Product Change Notice (PCN)

PCN Number: **PCN-0450899R-01**

Product(s) Affected: *SJ1-4251X Series. SJ1-42514, SJ1-42515TS & SJ1-42516*

PREVIOUS CUI DEVICES DETAIL / IMAGE		NEW CUI DEVICES DETAIL / IMAGE

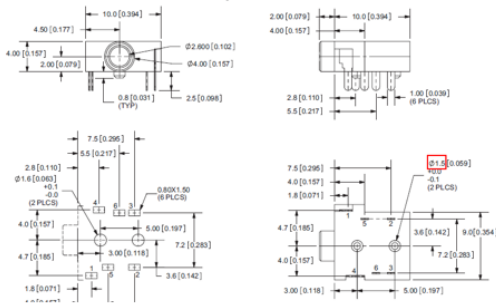
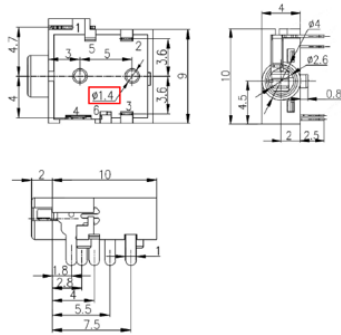
Description of Change: *Locating pin difference and material change. See image Below*

<table border="1"> <thead> <tr> <th></th> <th>MATERIAL</th> <th>PLATING</th> </tr> </thead> <tbody> <tr> <td>terminal 1</td> <td>copper alloy</td> <td>gold flash</td> </tr> <tr> <td>terminal 2</td> <td>copper alloy</td> <td>gold flash</td> </tr> <tr> <td>terminal 3</td> <td>copper alloy</td> <td>gold flash</td> </tr> <tr> <td>terminal 4</td> <td>copper alloy</td> <td>gold flash</td> </tr> <tr> <td>terminal 5</td> <td>brass</td> <td>gold flash</td> </tr> <tr> <td>terminal 6</td> <td>brass</td> <td>gold flash</td> </tr> <tr> <td>plastic</td> <td>PA66</td> <td></td> </tr> </tbody> </table>			MATERIAL	PLATING	terminal 1	copper alloy	gold flash	terminal 2	copper alloy	gold flash	terminal 3	copper alloy	gold flash	terminal 4	copper alloy	gold flash	terminal 5	brass	gold flash	terminal 6	brass	gold flash	plastic	PA66		<table border="1"> <thead> <tr> <th>DESCRIPTION</th> <th>MATERIAL</th> <th>PLATING/COLOR</th> </tr> </thead> <tbody> <tr> <td>terminal 1</td> <td>phosphorous bronze t=0.25</td> <td>gold flash</td> </tr> <tr> <td>terminal 2</td> <td>phosphorous bronze t=0.20</td> <td>gold flash</td> </tr> <tr> <td>terminal 3</td> <td>phosphorous bronze t=0.20</td> <td>gold flash</td> </tr> <tr> <td>terminal 4</td> <td>phosphorous bronze t=0.25</td> <td>gold flash</td> </tr> <tr> <td>terminal 5</td> <td>phosphorous bronze t=0.20</td> <td>gold flash</td> </tr> <tr> <td>terminal 6</td> <td>phosphorous bronze t=0.20</td> <td>gold flash</td> </tr> <tr> <td>housing</td> <td>PA66 [UL94V-0]</td> <td>black</td> </tr> </tbody> </table>		DESCRIPTION	MATERIAL	PLATING/COLOR	terminal 1	phosphorous bronze t=0.25	gold flash	terminal 2	phosphorous bronze t=0.20	gold flash	terminal 3	phosphorous bronze t=0.20	gold flash	terminal 4	phosphorous bronze t=0.25	gold flash	terminal 5	phosphorous bronze t=0.20	gold flash	terminal 6	phosphorous bronze t=0.20	gold flash	housing	PA66 [UL94V-0]	black

MATERIAL	PLATING																																																	
terminal 1	copper alloy	gold flash																																																	
terminal 2	copper alloy	gold flash																																																	
terminal 3	copper alloy	gold flash																																																	
terminal 4	copper alloy	gold flash																																																	
terminal 5	brass	gold flash																																																	
terminal 6	brass	gold flash																																																	
plastic	PA66																																																		
DESCRIPTION	MATERIAL	PLATING/COLOR																																																	
terminal 1	phosphorous bronze t=0.25	gold flash																																																	
terminal 2	phosphorous bronze t=0.20	gold flash																																																	
terminal 3	phosphorous bronze t=0.20	gold flash

terminal 4	phosphorous bronze t=0.25	gold flash																																																	
terminal 5	phosphorous bronze t=0.20	gold flash																																																	
terminal 6	phosphorous bronze t=0.20	gold flash																																																	
housing	PA66 [UL94V-0]	black
